WELL NAME Holcomb Blvd 700

CONTRACT NO 81-C-1644 TRANSMITTAL NO 126 DATE 11-12-85

PROJECT TITLE AND LOCATION
Holcomb Blvd Water Treatment Plant
Cp Lejeune, North Carolina

RE: N62470-81-C-1644
Expansion of Holcomb Blvd.
Water Treatment Plant
Camp Lejeune, NC 28542
Well #3

CAMP LEJEUNE No. 4 WELL
TITLE
 VERTICAL TURBINE PUMP WITH
 COMBINATION RIGHT ANGLE GEAR
 DRIVE WITH ENGINE & MOTOR
 DATE 1-26-81 SCALE NONE

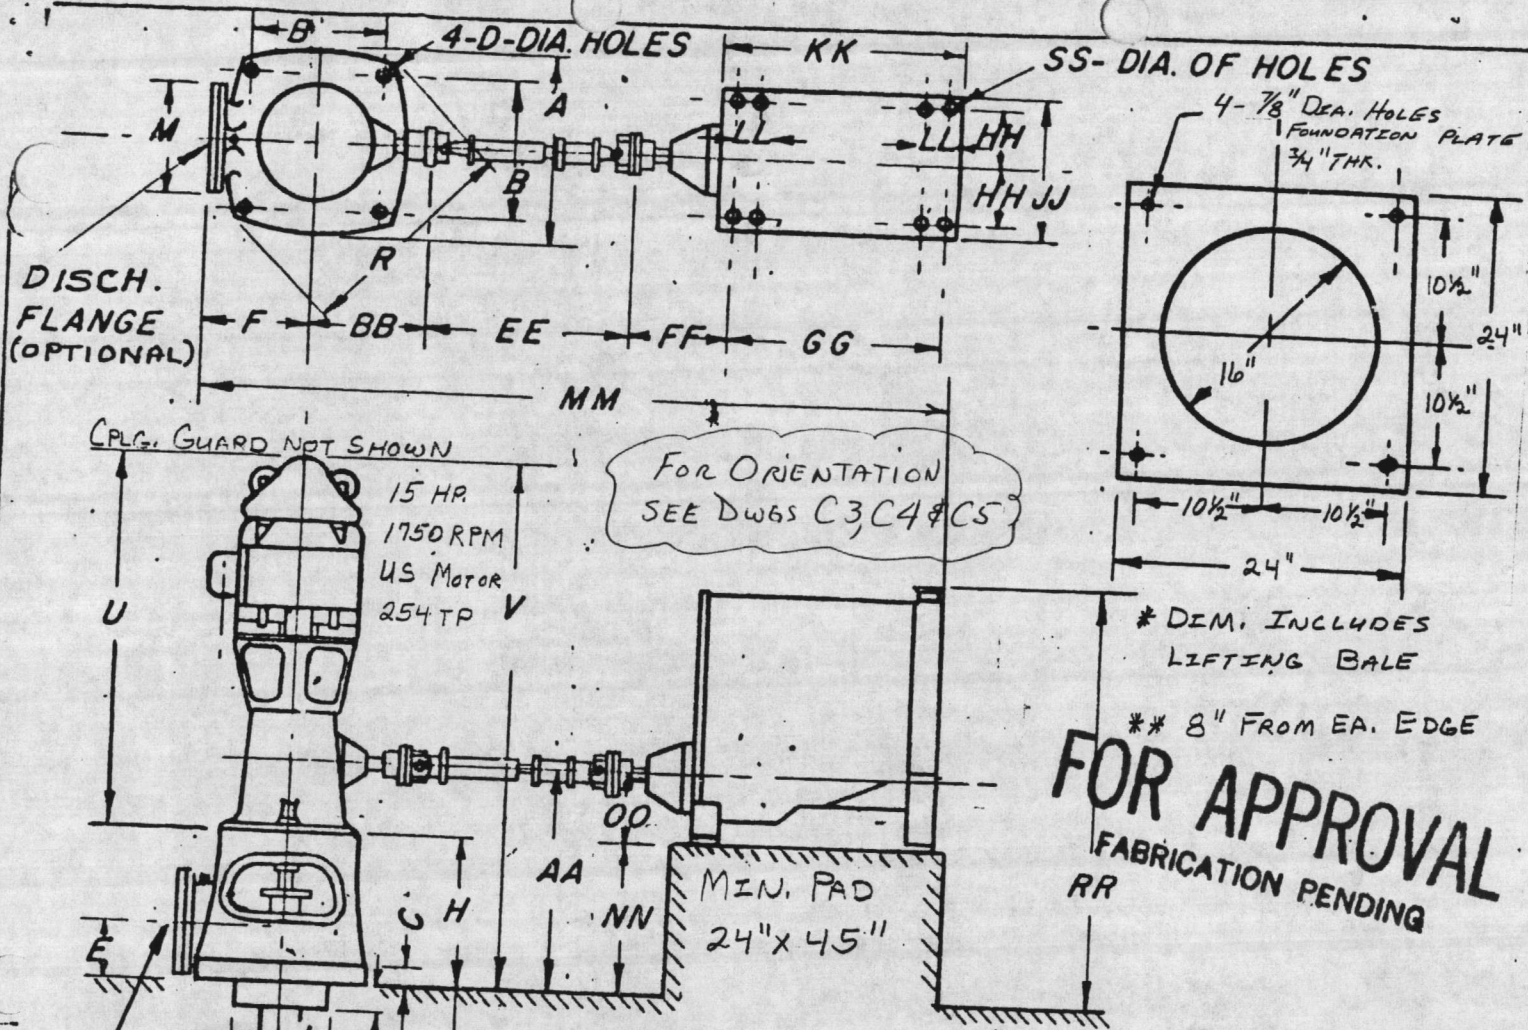
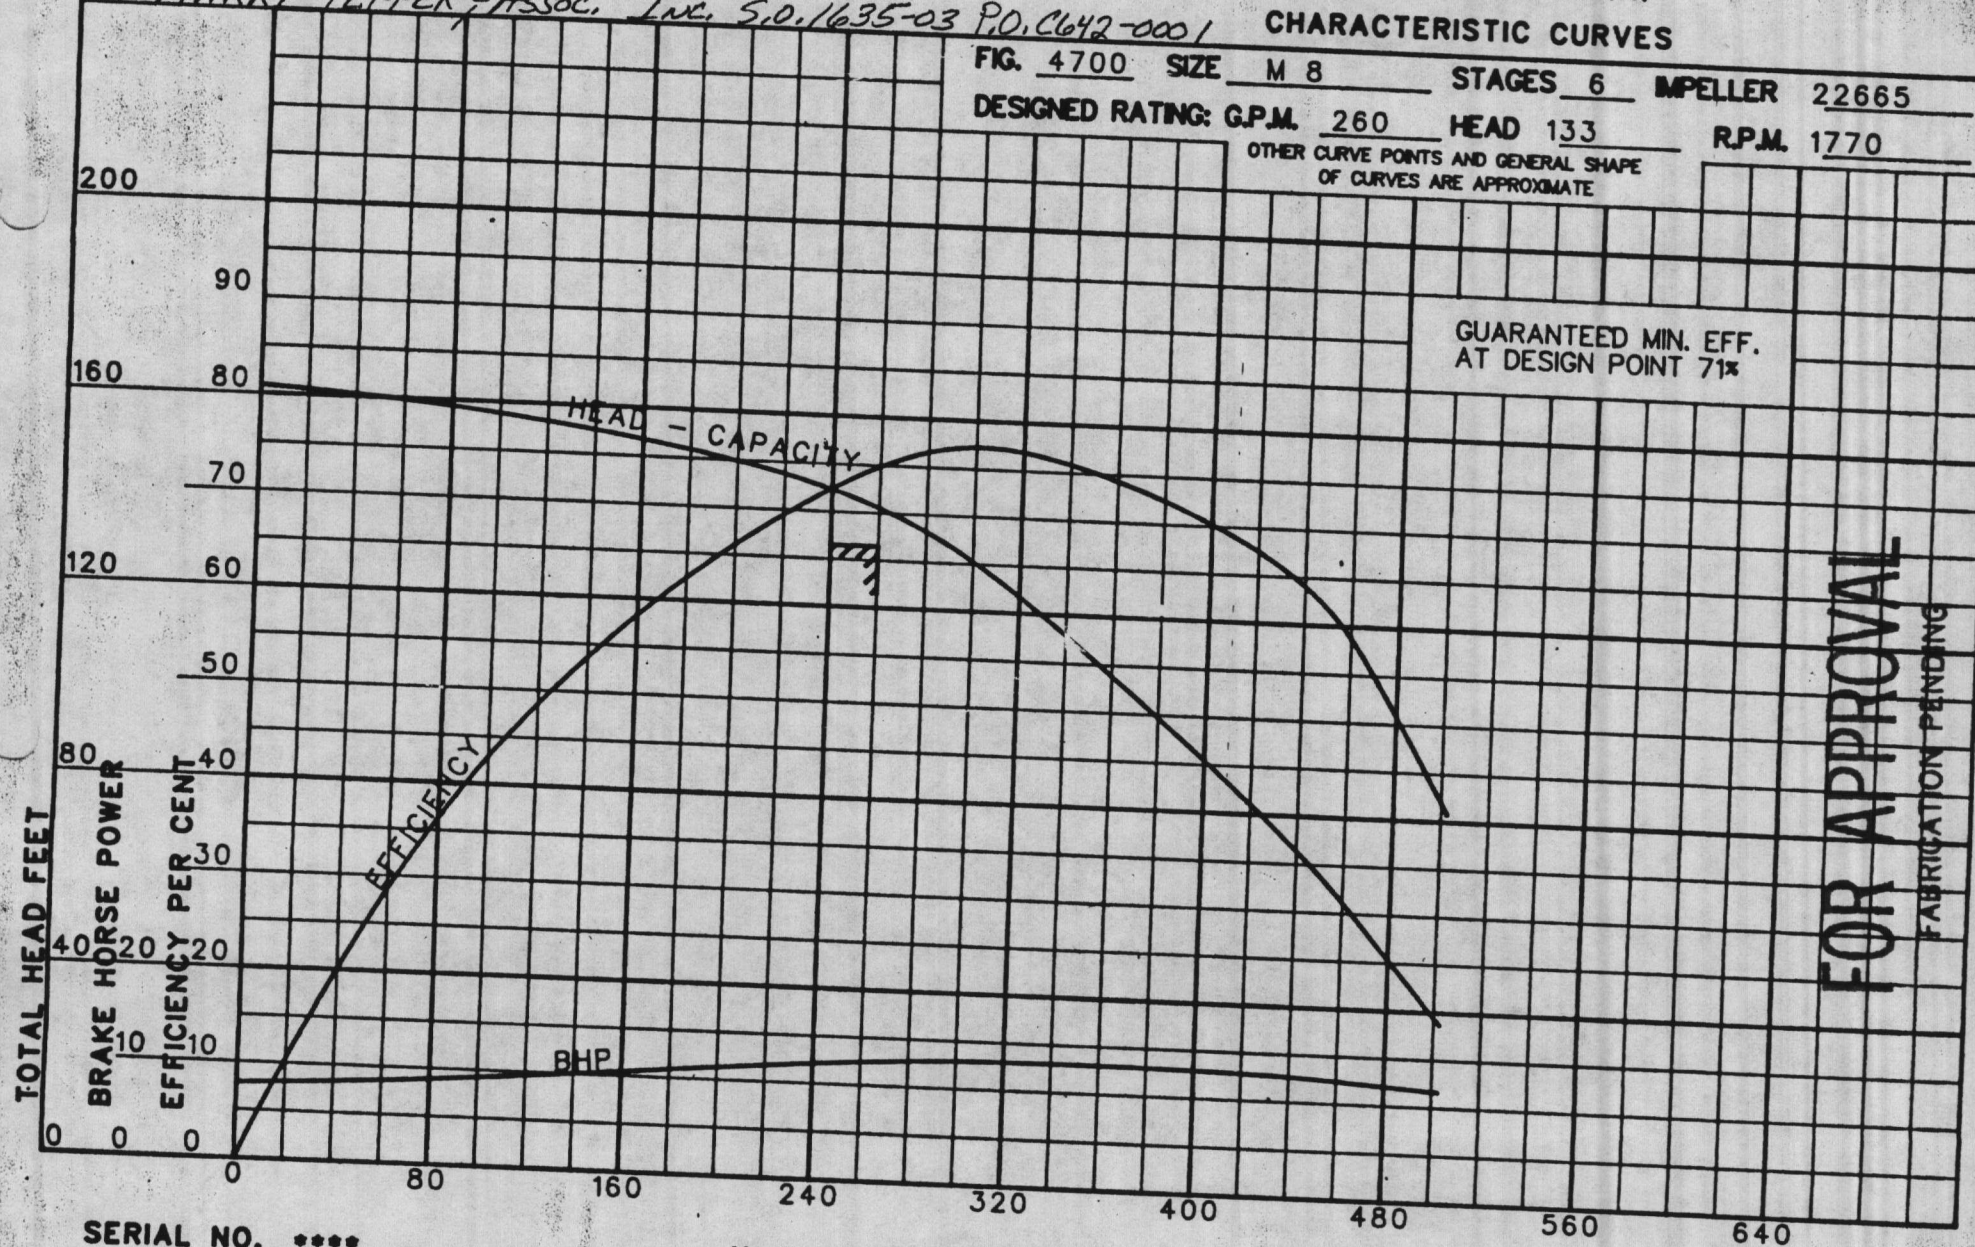
FOR APPROVAL
FABRICATION PENDING

FOR APPROVAL
FABRICATION PENDING
